Technical Memorandum – Victoria Cross ISD, SSSA Traffic & Green Travel Plan

Date:	27 March 2020
To:	Michael James (LendLease), Lulu Woods (Lendlease)
Cc:	Greta King (LendLease) Stephen Canty (ARCMAC)
From:	Nicole Vukic
Reference Document Numbers:	SMCSWSVO-LLC-SVC-TI-REP-000001, SMCSWSVO-LLC-SVC-TI-REP-000002

This technical memorandum responds to comments and recommendations within submissions made on the Victoria Cross OSD Detailed State Significant Development Application (SSD-10294), including the Transport for NSW (TfNSW) submission dated 20 December 2019 as well as relevant public submissions.

Figure 1 - Extract of Victoria Cross Station architectural layout showing future MLC breakthrough location

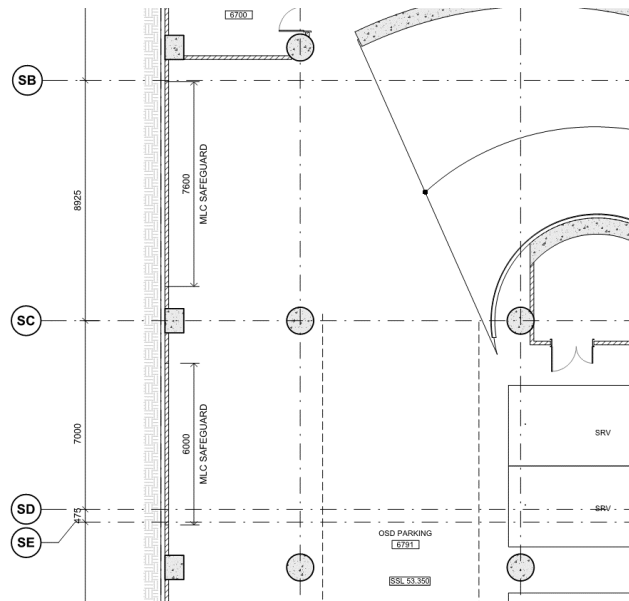
Further information should be provided on the future MLC breakthrough

As detailed in the architectural and structural design (refer to Figures 1 and 2) of the basement loading dock area, the proposed design allows for a future breakthrough into the adjacent MLC basement, for the connection of vehicle access via a shared loading dock as required in the Sydney Metro Victoria Cross Scope of Works and Technical Criteria (SWTC). This design is completed as part of the station works under the Critical State Significant Infrastructure project (CSSI) approval which includes the construction of all works below ground or above ground improvements with the metro station structure for appropriate integration with the OSD.
